Potential flaking on intake and exhaust cams

**PIELSTICK Engine – PA6B Ph4**

## Service Bulletin

No. 483932-00

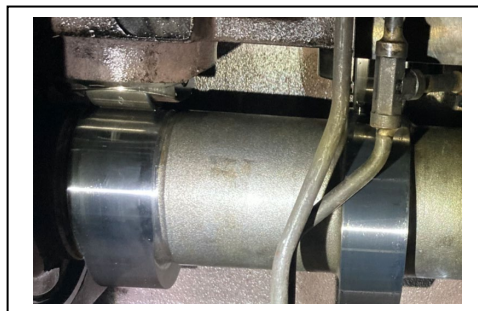
Ecaillage potentiel sur les cames admission et échappement

Nouvelle définition de galet pour éviter un phénomène d'écaillage.

Suite aux retours d'expérience, il a été constaté que, sur certains moteurs PA6B Phase 4 suivant les conditions d'opérations, des efforts importants peuvent apparaître à l'ouverture des soupapes admission et échappement.

Pour limiter les contraintes mécaniques sur les cames, un nouveau modèle de galet a été développé.

- Application *groupe secours nucléaires* => Contrôle visuel à effectuer sur les galets et cames à 6 ans comme préconisé dans le Manuel d'Entretien et remplacement à prévoir à la prochaine « décennale » (Voir NT-04 du Manuel d'Entretien).
- Application *centrale de base/marine/marine militaire*: Remplacement des galets à la prochaine maintenance.

Si un début d'écaillage des cames devait être visible au contrôle visuel, alors remplacer le tronçon d'Arbre à Cames ainsi que les galets d'admission et d'échappement.

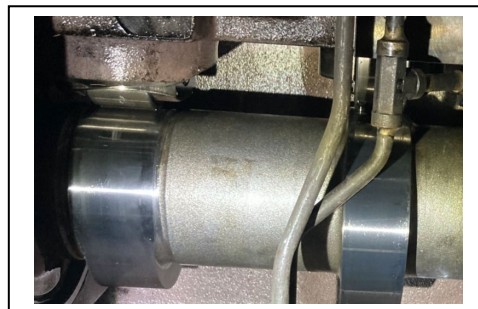
New roller design to prevent flaking phenomenon.

Following feedback from field experience, it has been observed that, on certain PA6B Phase 4 engines and depending on operating conditions, high forces may occur during the opening of the intake and exhaust valves.

To reduce mechanical stresses on the cams, a new roller design has been developed.

- *Nuclear standby generator* application ⇒ Visual inspection of rollers and cams to be carried out at 6 years as recommended in the Maintenance Manual, with replacement to be scheduled at the next ten-year major overhaul (see NT-04 of the Maintenance Manual).
- *Base load power plant / marine / naval* applications: Roller replacement at the next scheduled maintenance.

If the onset of cam flaking is observed during the visual inspection, the camshaft section as well as the intake and exhaust rollers must be replaced.
